METFORD MEDICAL

ARCHITECTURAL DRAWING SCHEDULE

ISSUE FOR DA

REVISION 2 UPDATES (01/12/23)

DRAWING : SHADOW DIAGRAMS

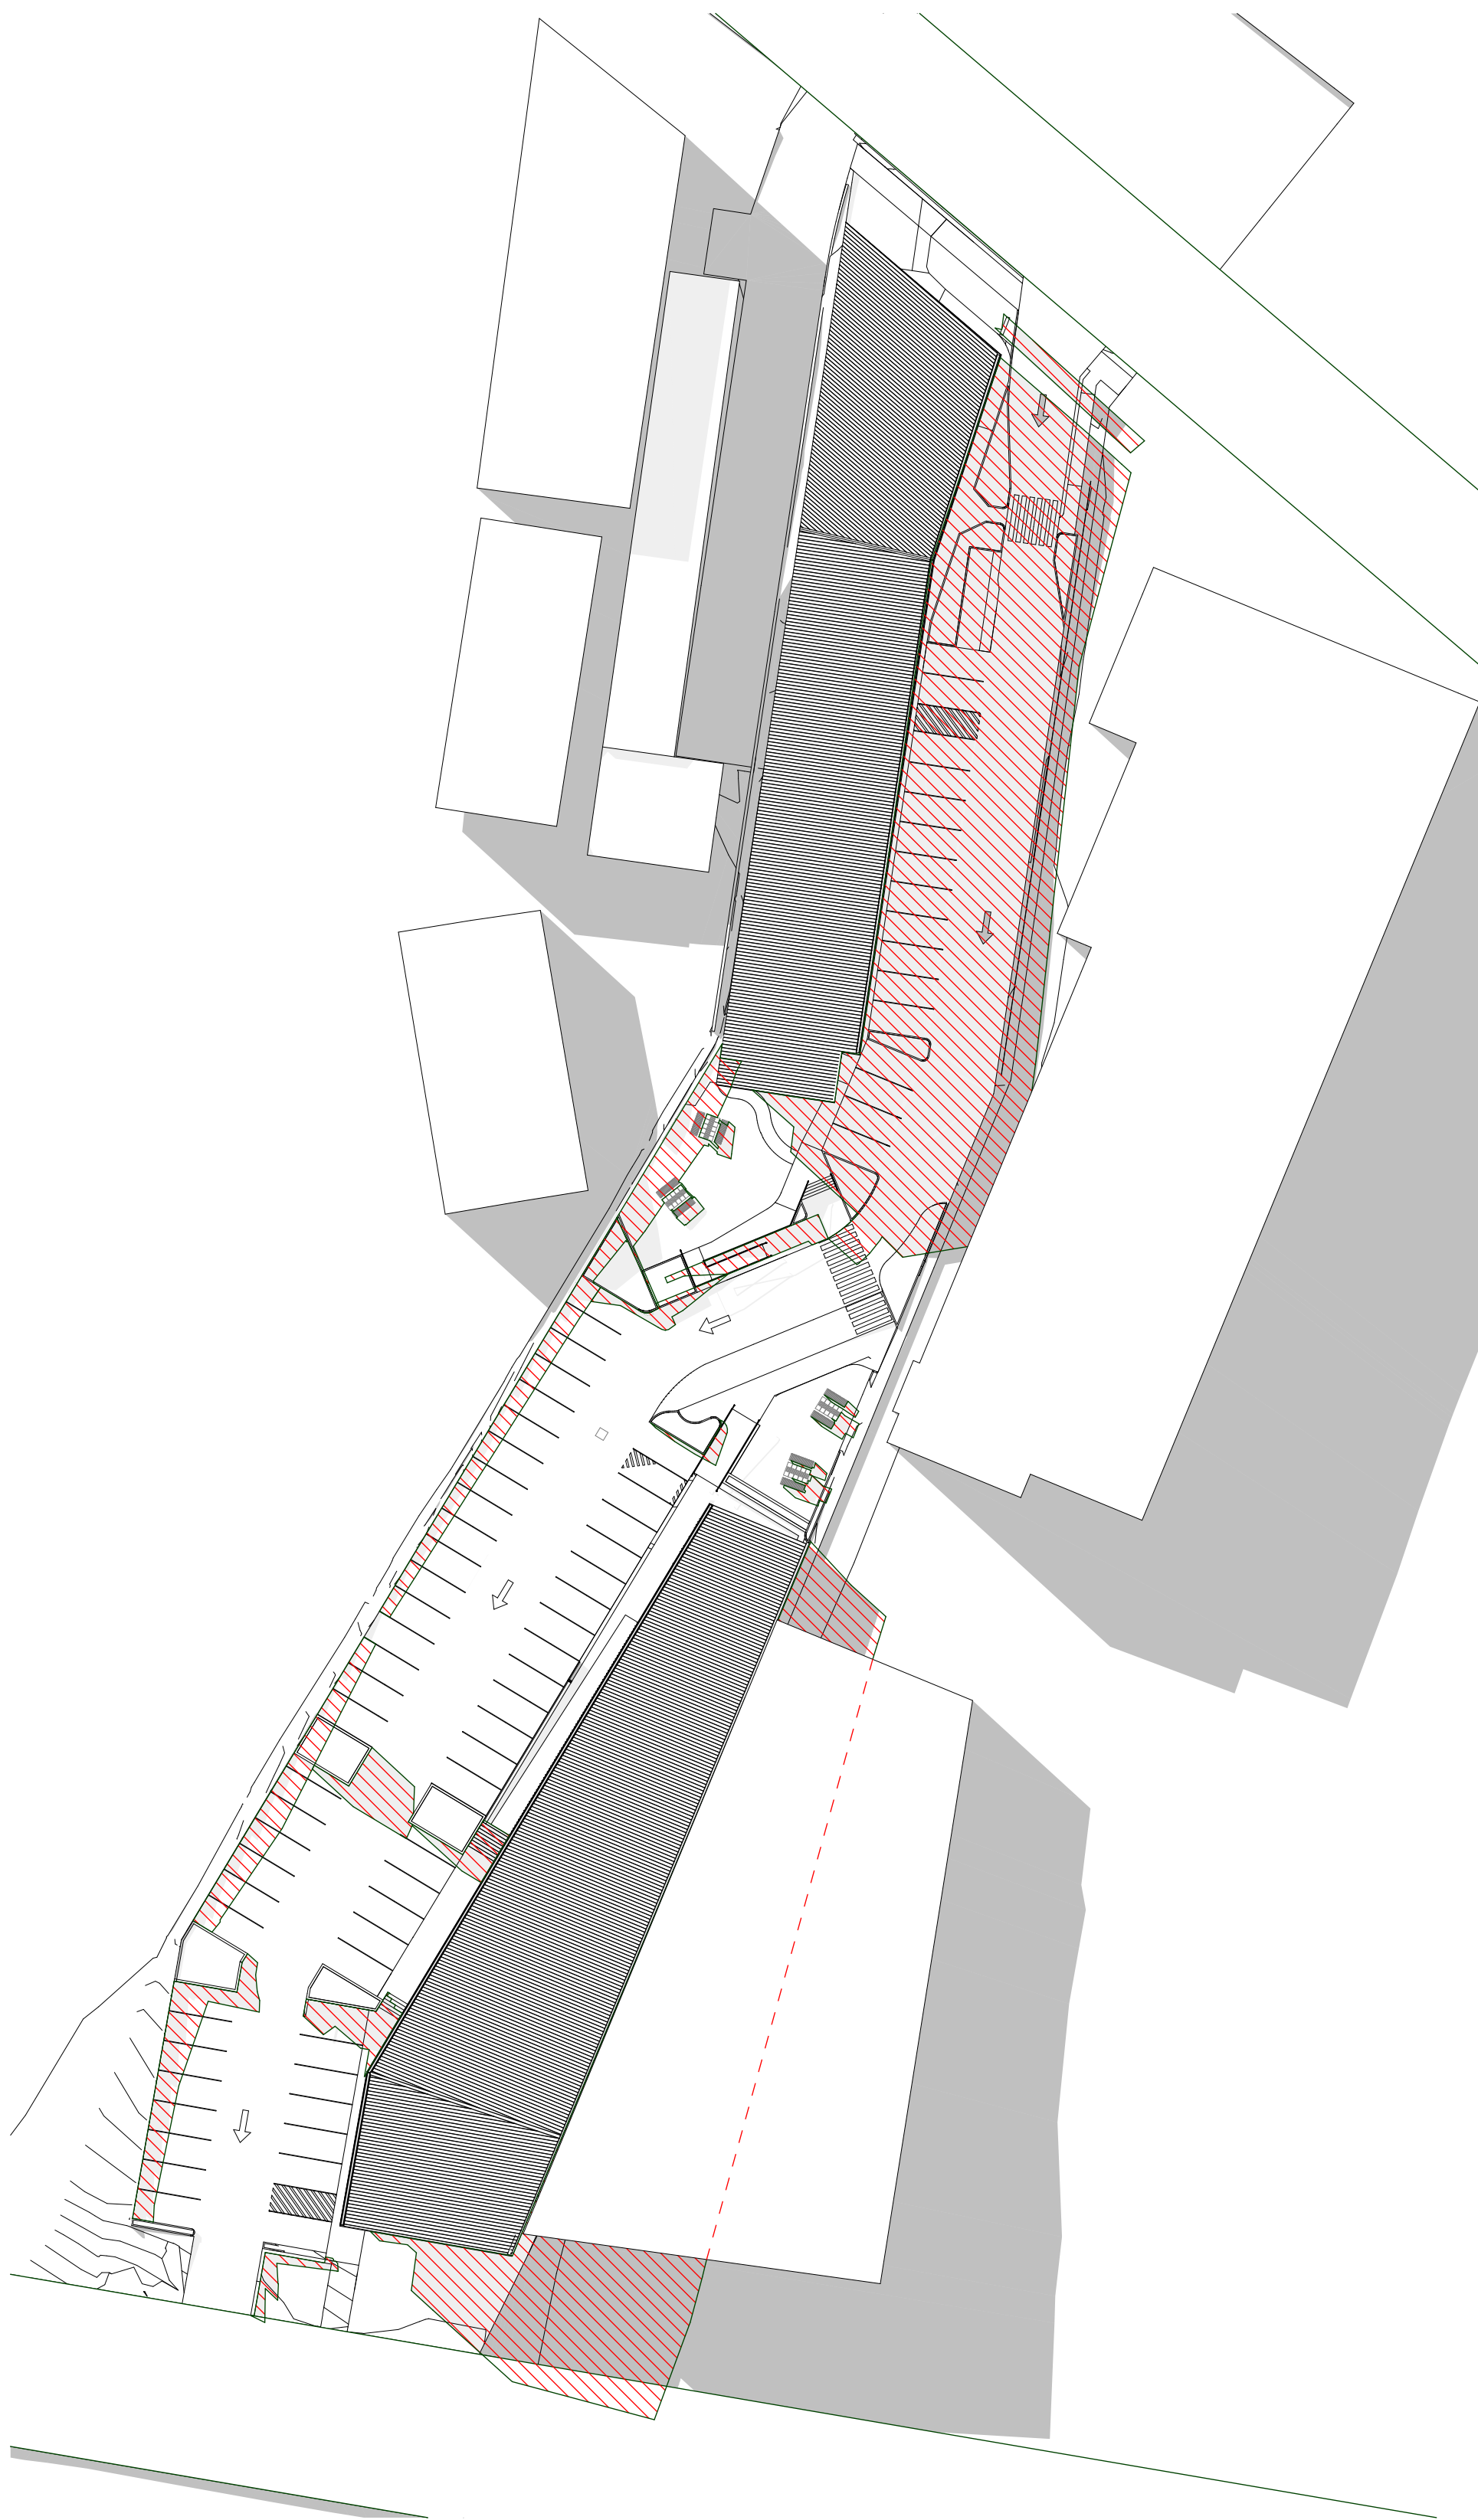
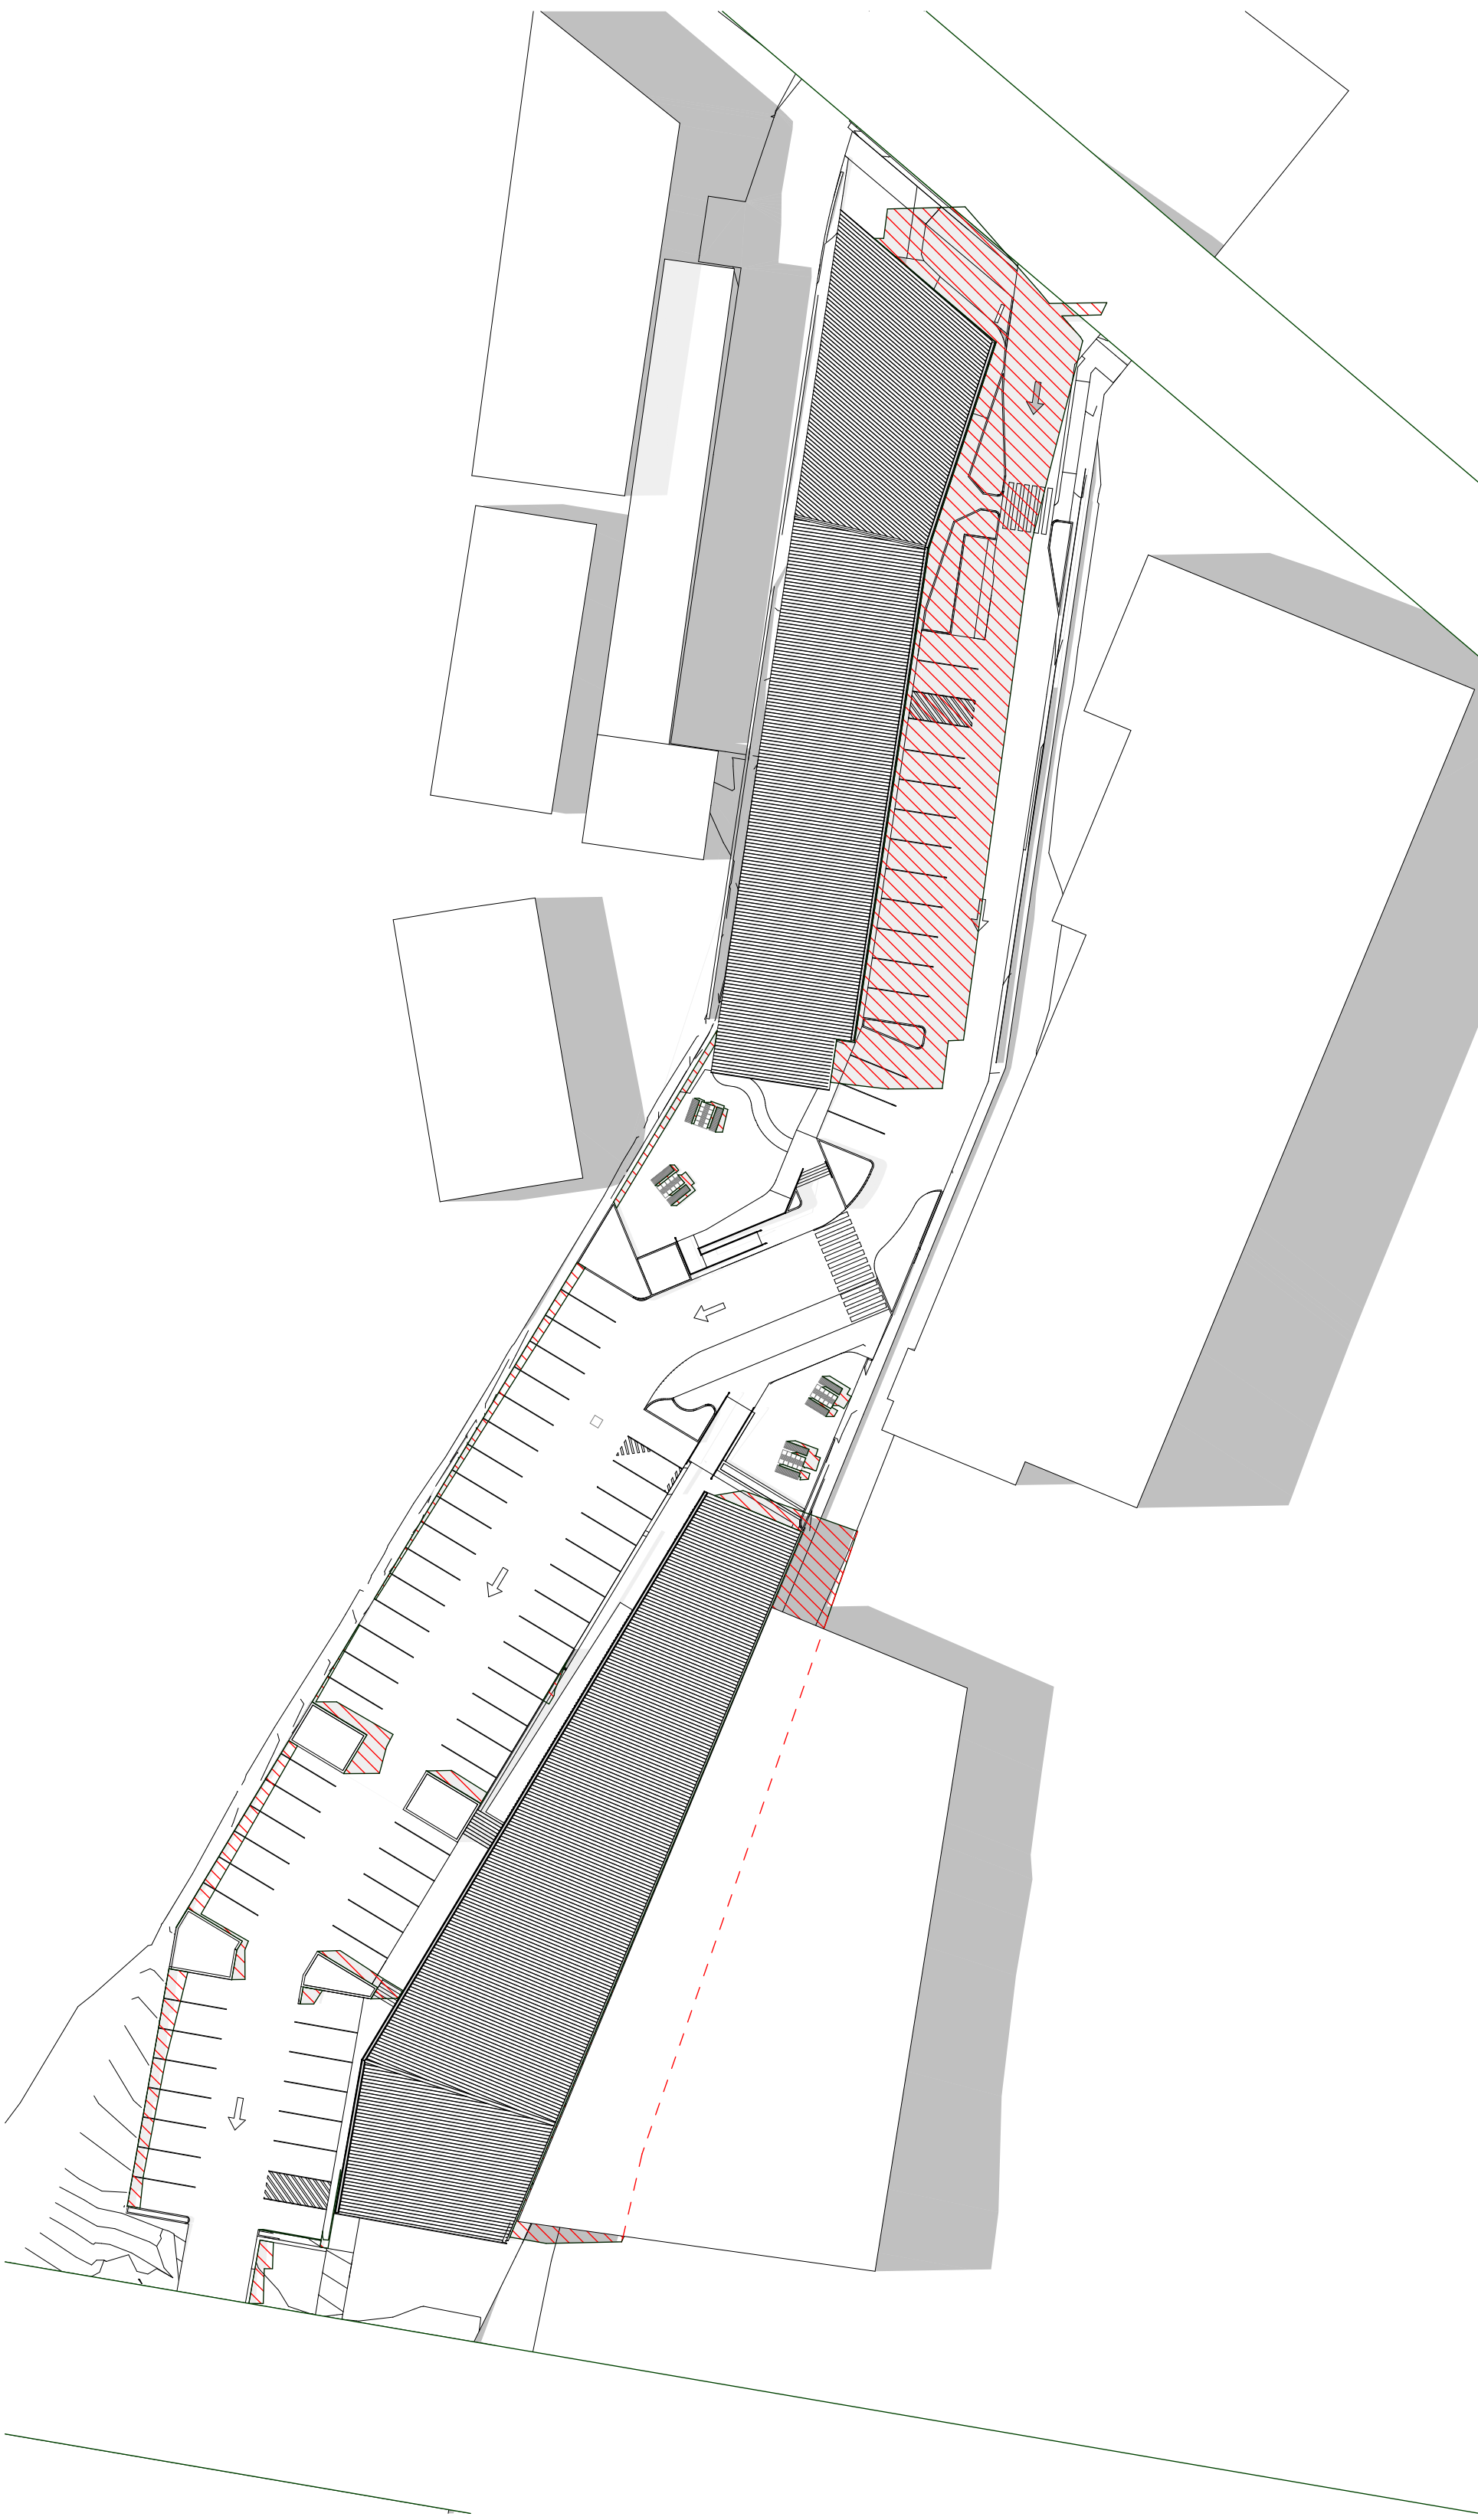
REVISION 2 UPDATES (01/12/23)
- BUILDING A STREET FRONTAGE BULK REDUCED
